M24C32T-FCU package mechanical data modifications

This errata sheet applies to the M24C32T-FCU, that is the 32 Kbit serial I²C bus EEPROM delivered in WLCSP four balls.

The impacted part number is M24C32T-FCU6T/TF.

Figure 2. D and E front side view

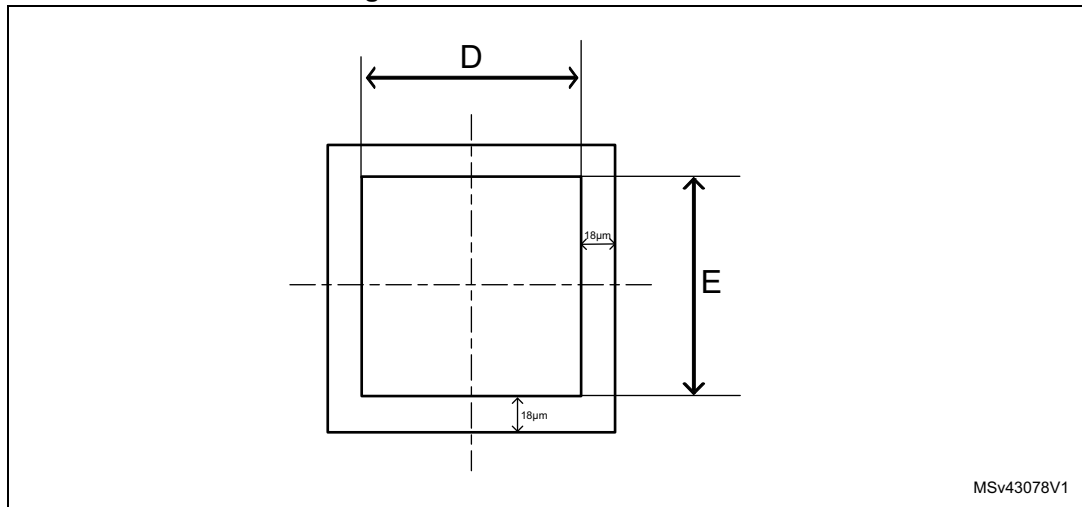
- The D and E values on M24C32T-FCU datasheet correspond to front side view (ball side), instead of back side view (marking side view).
[Table 1](#) and [Table 2](#) report the data for the front and back view, respectively.

Symbol	Millimeters			Inches		
	Min	Typ	Max	Min	Typ	Max
D	-	0.833	0.853	-	0.0328	0.0336
E	-	0.833	0.853	-	0.0328	0.0336

Figure 3. D and E back side view

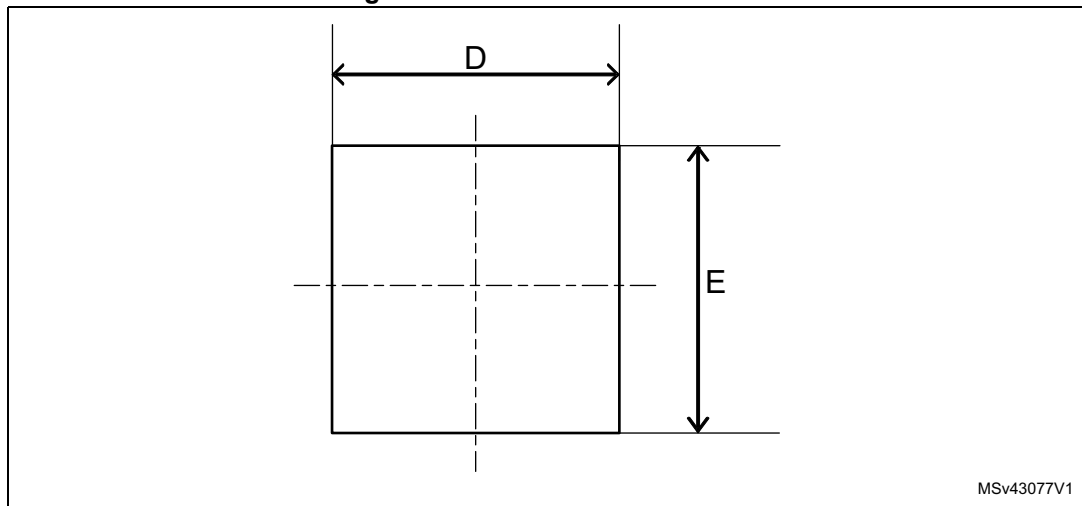
This document refers to the changes of dimensions D and E (see [Figure 3](#)) described in the M24C32T-FCU datasheet, in tables detailing the dimensions of the Ultra Thin WLCSP 4-bump package.

D and E values must be modified to correct the following mistake:

Symbol	Millimeters			Inches		
	Min	Typ	Max	Min	Typ	Max
D	0.831	0.851	0.871	0.0327	0.0335	0.0343
E	0.831	0.851	0.871	0.0327	0.0335	0.0343

Figure 4. D or E side view

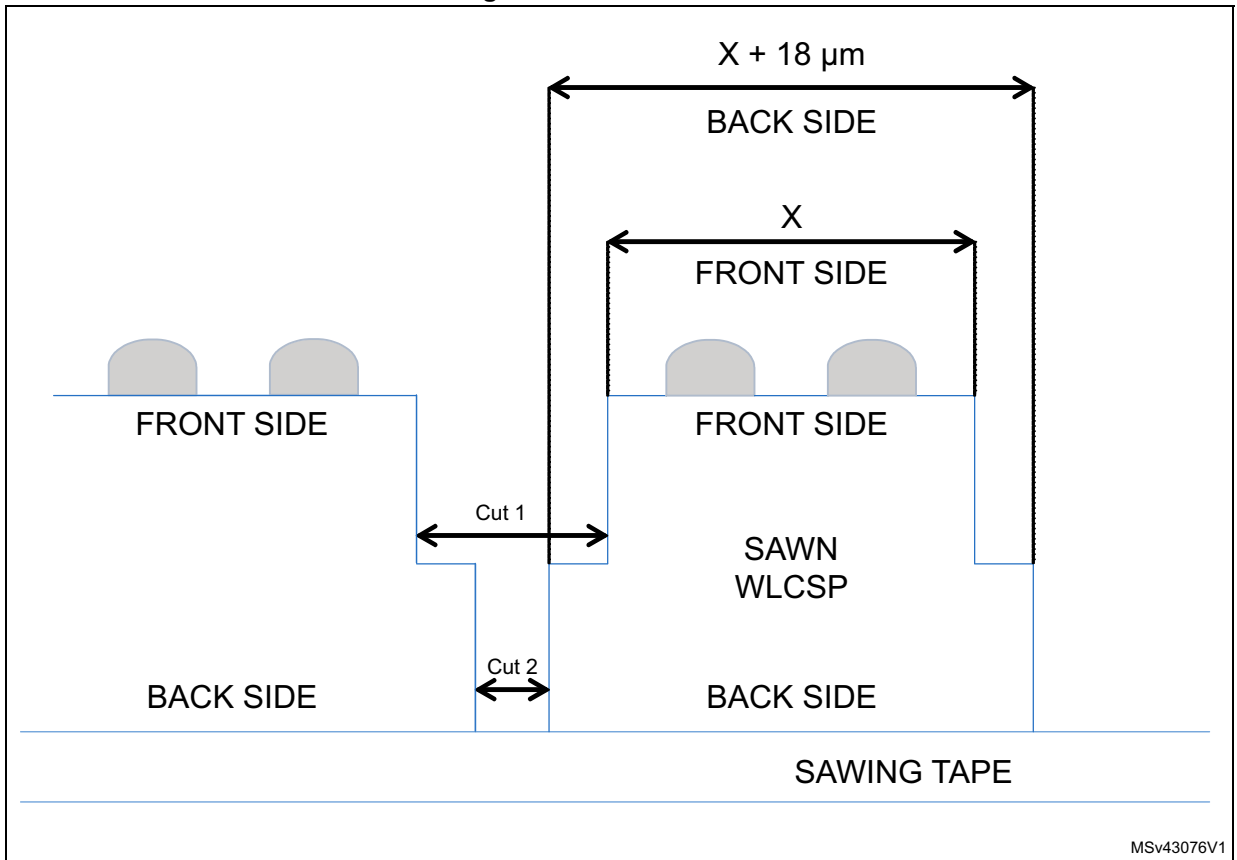
The difference between back side and front side dimension is 18 μm (0.018 mm). This difference is due to two-step sawing process, where cut 1 and cut 2 are performed with blades having different thickness (see [Figure 4](#) in which X represents D or E and it has the same value and tolerance).
